TITLE REDUCE POSITIONER EMERGENCY UNLOAD VELOCITY				PIB NO. DK3069
PRODUCT LINE	TAPE DISK FORMATTER X	EQUIPMENT CHANGED Servo	MODEL SERIES AFFECTED D3000	EFFECTIVE DATE 3/30/77

TITLE REDUCE POSITIONER EMERGENCY UNLOAD VELOCITY

PIB NO.
DK3069

Sheet 1 Zone 10-B

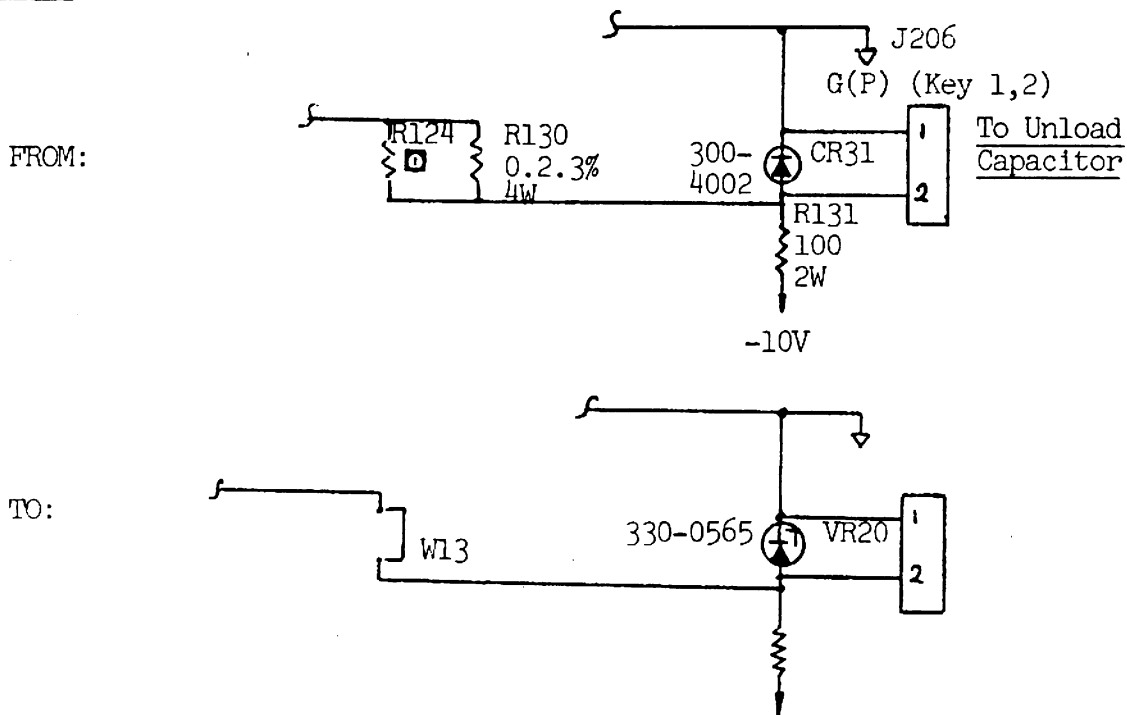
BOARD/DRAWING/MANUAL CHANGES: DWG. 102810, Servo Schematic

In <u>Delete</u> Column	ADD: CR31, R129 & R130
In <u>Last Used</u> Column	FROM: VR19 to VR20
	FROM: W12 to W13

Sheet 3 Table I

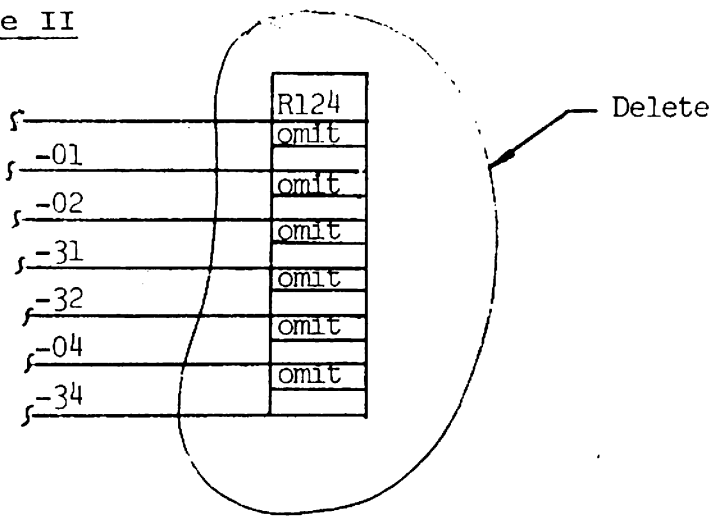
Delete: R130 at 115-0002	Add: 691-9022 W13
Delete: CR31 at 300-4002	330-0565 VR20

Zone 5/6 - F

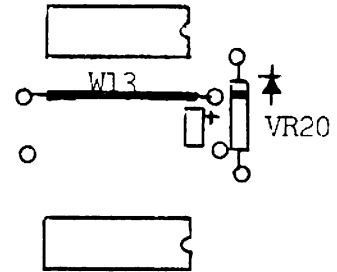
DWG. 102811, Servo PCBA

FROM:

TO:

ADD: Wire (W13) in location of R129
Diode, Zener (VR20) in location of CR31
